Groundwater Transfer Review Summary Form

Transfer/PA # T- 13898

Application: T-13898

Applicant Name: Philip and Penelope Knight

Transfer Map

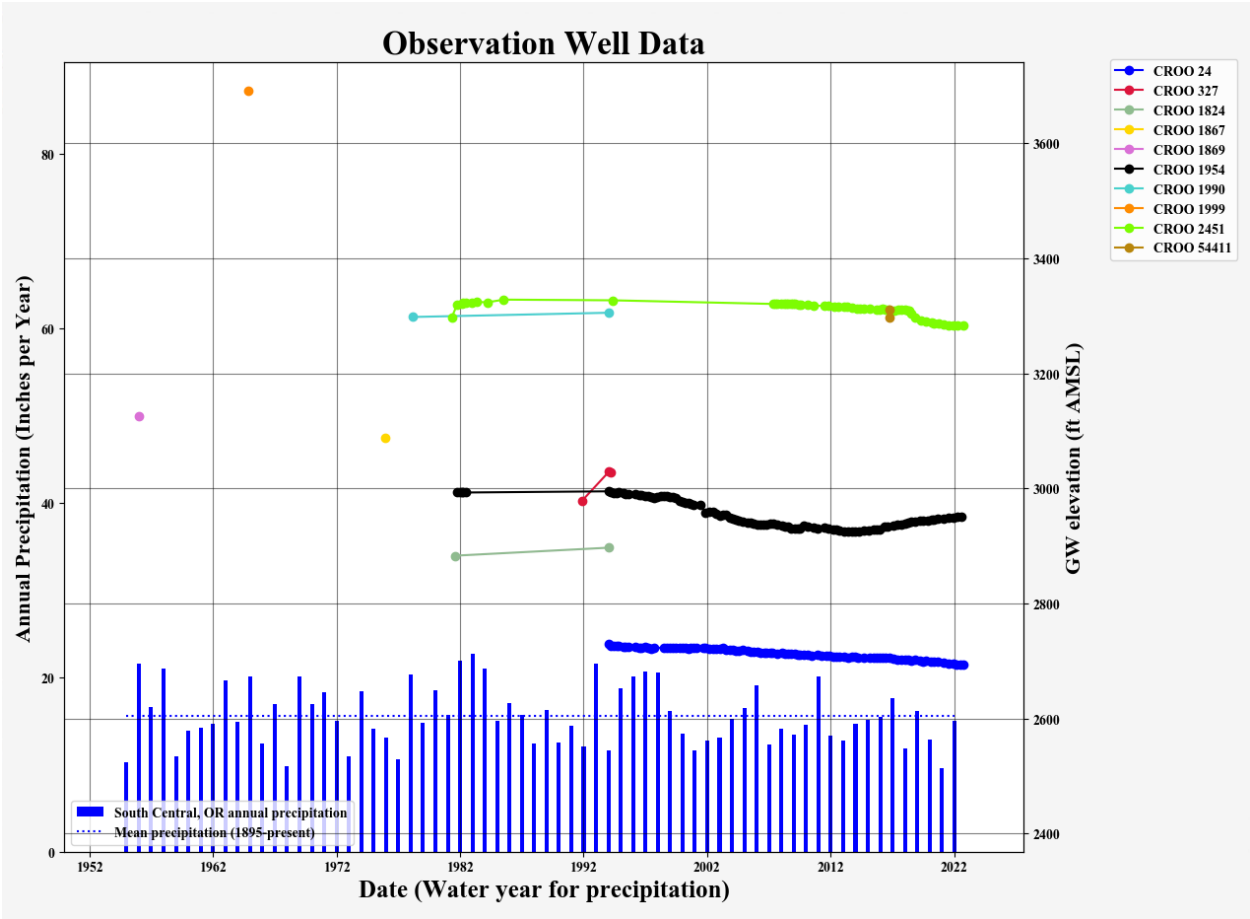
1. Basic description of the changes proposed in this transfer: The applicant proposes to 1) move 20 acres of irrigation use (0.25 cfs) from CROO 1867 and CROO 1869 under certificate 93255 to JEFF 51644 and 2) move 113.8 acres of irrigation (1.42 cfs) from CROO 1999 and CROO 54411 under certificate 94893 to JEFF 51644. The transfer also proposes to change the place of use and the character of use from irrigation to nursery to allow for layering with COID water deliveries.

2. Will the proposed POA develop the same aquifer (source) as the existing authorized POA?
☐ Yes ☒ No Comments: "From" wells CROO 1867 and CROO 1869 develop groundwater from an aquifer hosted in alluvial fan deposits mantling Powell Buttes. "From" wells CROO 54411 and CROO 1999 access an aquifer hosted within the low-yielding silicic bedrock of Powell Buttes (considered part of the John Day Formation). These aquifers are recharged from precipitation falling directly onto Powell Buttes (Gannett, 1987). Groundwater level elevations in CROO 1867 and CROO 1869 are approximately 3100 feet AMSL. Groundwater levels in CROO 1999 and CROO 54411 are ~3700 feet amsl and 3300 feet amsl respectively. This is several hundred feet higher than the regional groundwater system hosted in the Deschutes Formation, which sits at approximately 2700 feet AMSL adjacent to Powell Buttes (see CROO 24). In summary, the "from" wells produce from an aquifer system hosted in geological material that is distinct from the Deschutes Formation, receives local recharge from Powell Buttes, and has high groundwater levels than the regional groundwater system hosted in the Deschutes Formation.

The “to” well JEFF 51644 is located approximately 15 miles NW of the “from” wells. It primarily accesses the regional groundwater system hosted in the Deschutes Formation. (It may also access some water hosted in secondary fractures and joints of the lower yielding John Day Formation at a depth of ~900 feet bls.) This regional aquifer system is recharged primarily from snow and rain in the Cascades mountains and Newberry crater. The “to” accesses a distinctly different aquifer (long regional flowpaths from the Cascades to the the lower extent of the Deschutes Formation) than the “from wells (local flowpaths recharged from Powell Butte into associated volcanics and associated sediments).
